## Meeting Minutes Transmittal/Approval

Unit Managers Meeting: Grout Treatment Facility  
Westinghouse Office, Lacey, Washington  
Meeting Held April 23, 1992

Engineering Change Notices (B-714-114, -117, -118, -119, -120, -121 & -122)

Ref. Dwg. H-2-77582	Sh. 2	Rev. 0	Prepared By T.K. EHRHARD	Checked By <i>S.D. Consort</i>	ECN No. B-714-121	Page 8/8
H-2-78451	2	0

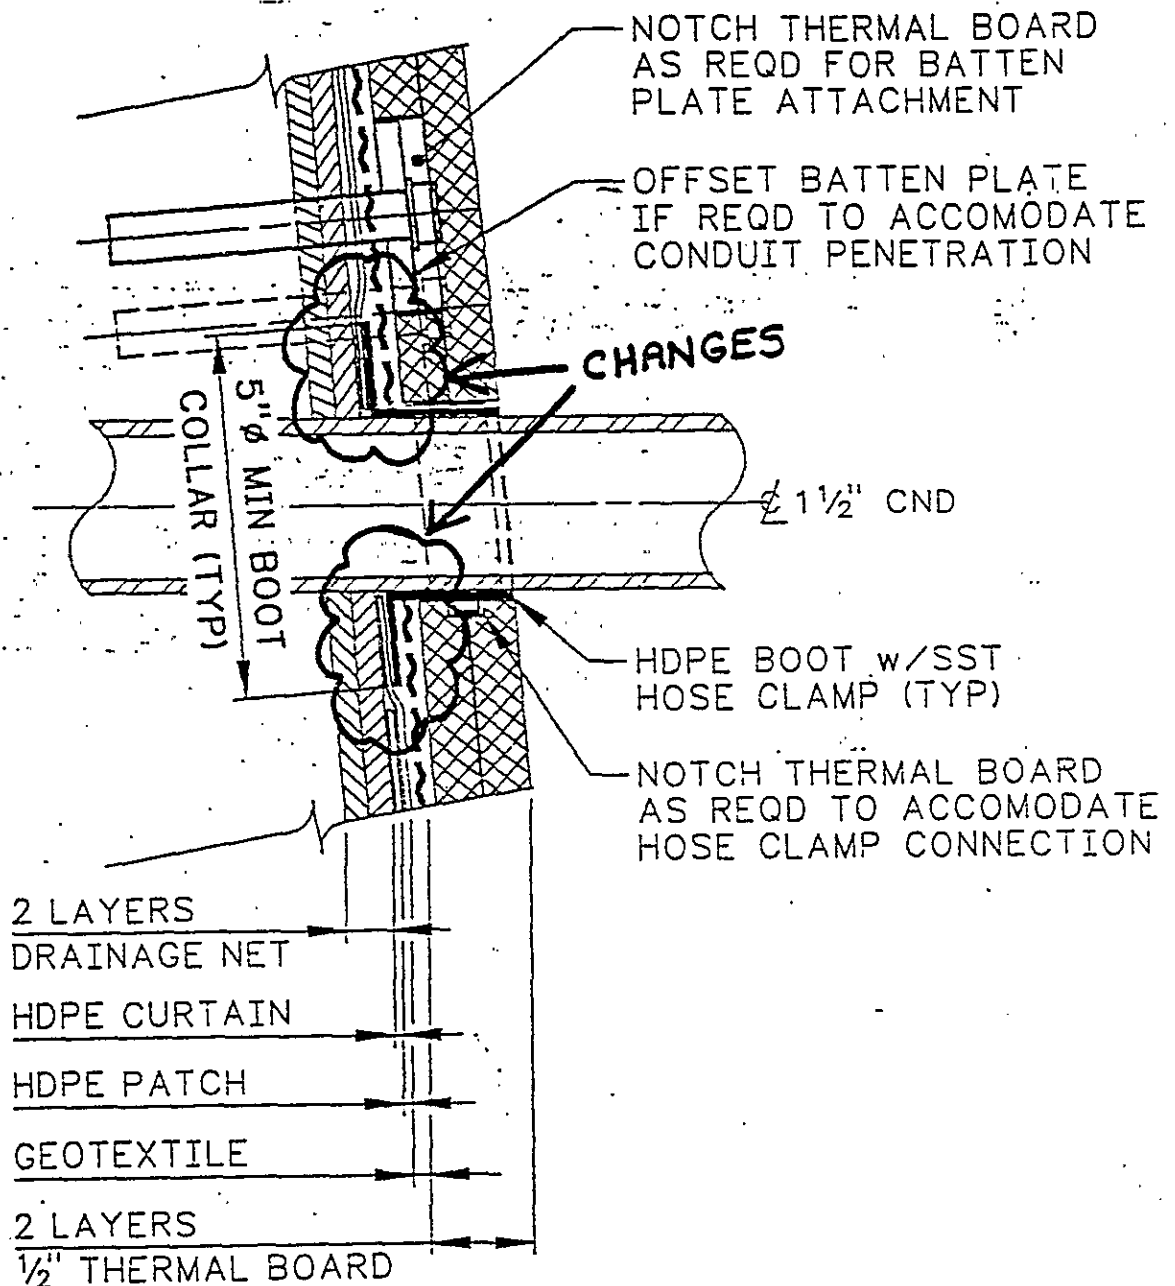
A) Detail 4 (ZE-F3): Relocate HDPE boot to outside of HDPE patch as shown on page 8 of this ECN.

A) Detail 5 (ZE-F3): Relocate HDPE boot to outside of HDPE patch as shown on page 8 of this ECN.

Ref. Dwg.	Sh.	Rev.	Prepared By	Checked By	ECN No.	Page
H-2-77599	1	1	D. McDORMAN	M.A. McLean	B-714-122	6/8
H-2-78470	1	0

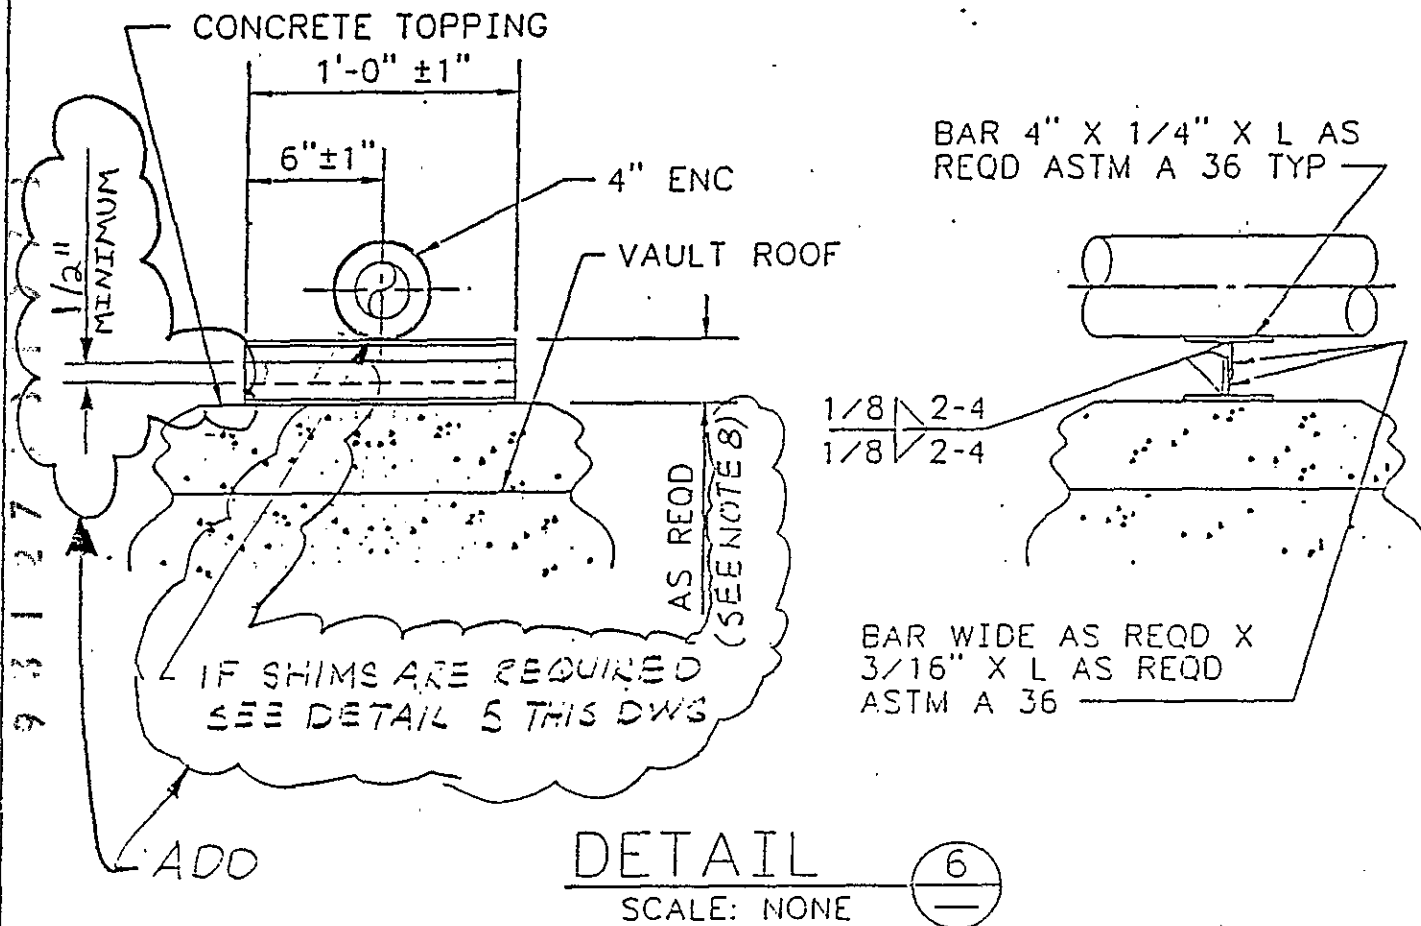
- A) Detail 5: Replace old detail with new detail as shown on page 5 of this ECN. (Affects ECN B-714-93, page 1, item 3B).
- B) Detail 6: Add "SEE NOTE 8", shim callouts & overlap dimension as shown on page 6 of this ECN. (Affects ECN B-714-93, page 4).

- Add new Notes 8, 9, & 10 as follows:
8. WHEN HEIGHT BETWEEN TOPPING SLAB AND BOTTOM OF PIPE IS OVER 4", USE DETAIL 6 OR 7 AT CONTRACTOR'S OPTION.  
WHEN HEIGHT BETWEEN TOPPING SLAB AND BOTTOM OF PIPE IS 1-7/8" TO 4", USE CONCRETE/SOLID MASONRY BLOCKS (COMMERCIALY AVAILABLE), MINIMUM SIZE 1-7/8" THICK x 4" WIDE x 6" LONG.  
WHEN HEIGHT BETWEEN TOPPING SLAB AND BOTTOM OF PIPE IS LESS THAN 1-7/8", USE ASTM A 36 AND A 569 SHIMS AS REQUIRED. WELD SHIMS TOGETHER AS SHOWN IN DETAIL 5.

Ref. Dwg.	Sh.	Rev.	Prepared By	Checked By	ECN No.	Page
H-2-77599	1	1	D. McDORMAN	M. R. McLean	B-714-122	7/8
H-2-78470	1	0

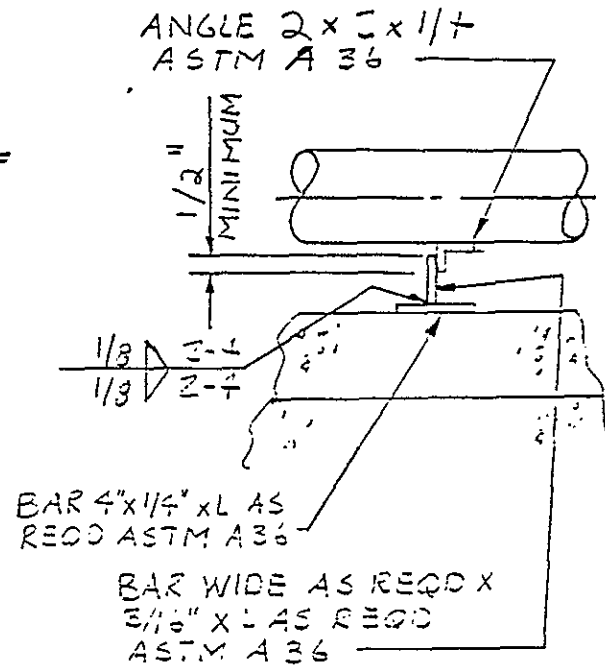
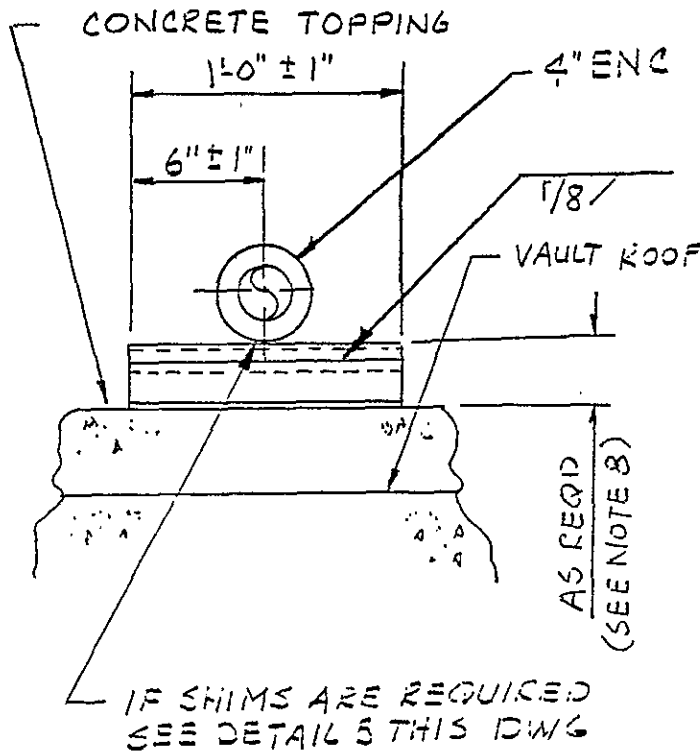
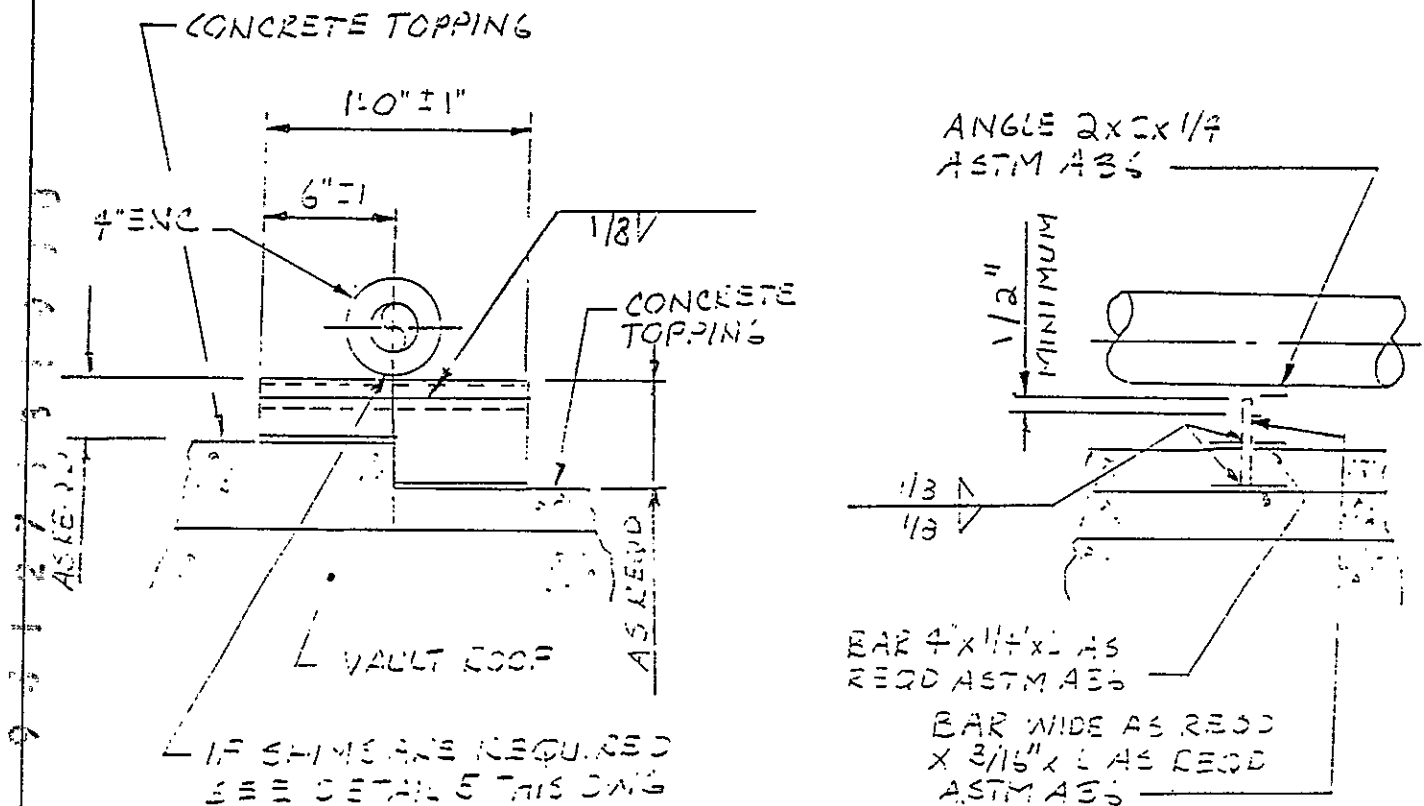
- C) Detail 7: Add new detail as shown on page 7 of this ECN.
- D) Detail 8: Add new detail as shown on page 8 of this ECN.
- E) Notes:
- Change Note 7 to read: CONCRETE BASE SUPPORTS ON SOIL SHALL BE ...

9. USE DETAIL 8 WHERE THE BASE OF A METAL PIPE SUPPORT OVERLAPS ABRUPT ELEVATION CHANGES IN THE TOPPING SLAB.
10. PROVIDE ~~TEMPORARY~~ <sup>TEMPORARY MEMBERS</sup> SUPPORT AS REQUIRED TO POSITION PIPE SUPPORT PRIOR TO AND DURING PLACING DIFFUSION MATERIAL.
